From: [REDACTED]
To: [REDACTED]
Sent: 2/24/2021 9:37:22 AM
Subject: RE: O8W-PM 35217268, 35224712, 35224713 - Bucks Creek 1101 Phase 1,2&3 - Pre-Engineering Meeting

PM 35217268 (Phase 1)

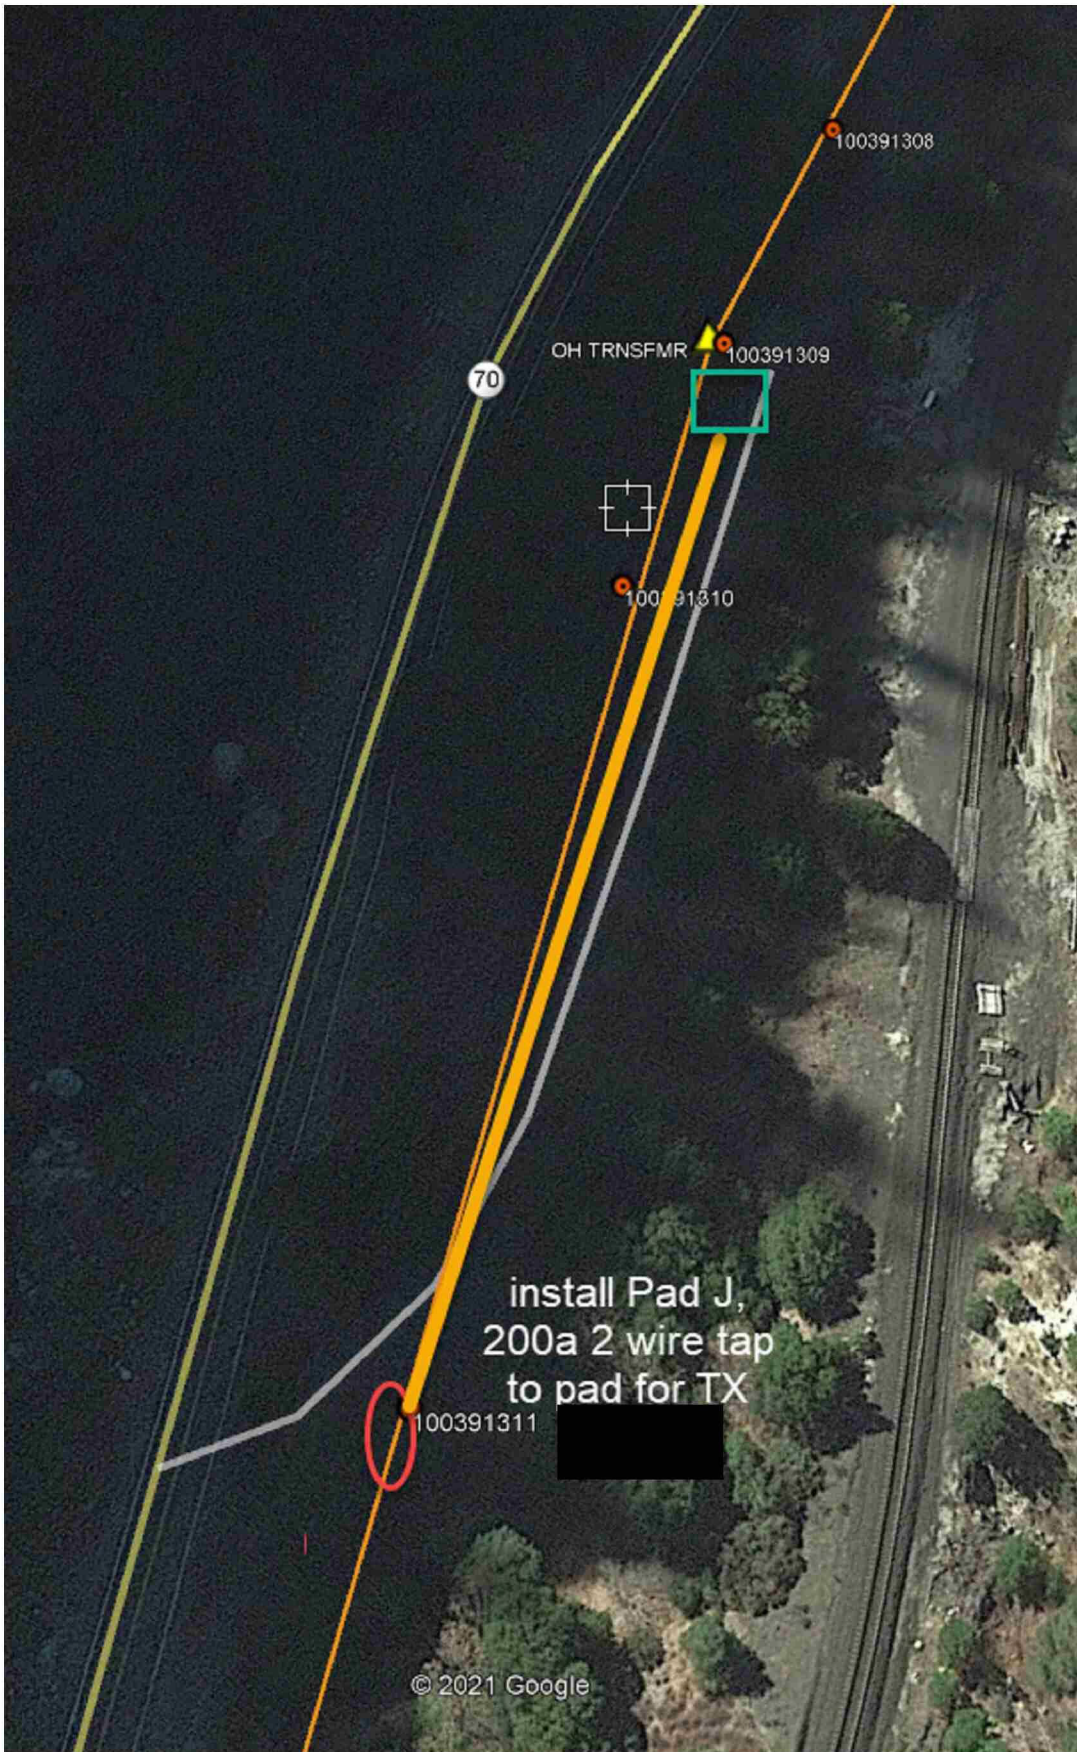
Your outlet red-line Bucks Creek looks close to what I was thinking. Need to work with [REDACTED] to get this designed with a single 6" and use #5 boxes with 200A cable. There is not a reason this will need (2) 6" and 1-4" and 7 boxes. There is probably only 20a peak on the primary now.

Before we involve Cal T and [REDACTED] it would be good to scope with the estimator so we can address the local folks with a somewhat solid plan. If we can establish the outlet for Bucks Creek Sub + the TX locations for Cresta Dam and [REDACTED] that should take most of the questions away. Rock Creek Bridge is the only thing I saw a big issue with. The local guys can help us once we determine what we are doing and make sure we get the details correct for permit.
